National Service Technical Bulletin

2021-06-013 - Warranty Extension - Civic Front Parking Sensor Misdetection While Driving (6P3)

To : All Honda Motor Vehicle Dealers

Date: 22 June 2021

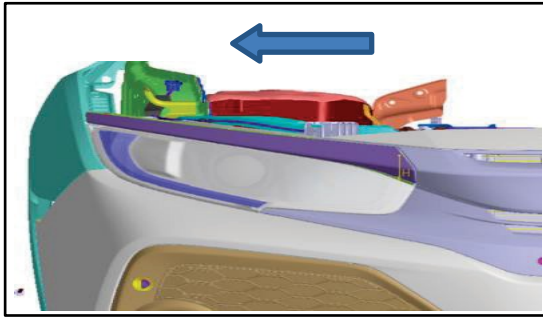
1. Replace front grill as per Maris II
2. Inspect the clearance between Headlight and Front Grill is 1.2 mm to 2.5 mm (A)

If the clearance is out of the tolerance range between 1.2 mm to 2.5 mm please adjust LH&RH head light position by the following procedure.

3. Detach the bolt A and B and C

4. Move the head light to outer B direction and adjust the clearance amount between head light and front grill 1.2mm to 2.5mm.

If the tolerance cannot be achieved, please adjust and balance the clearance between the Front grill LH and RH side headlight.

5. Fasten the bolt A and B and C
6. Adjust position on the other side of headlight.
7. Do headlight adjustment as per Maris instruction.
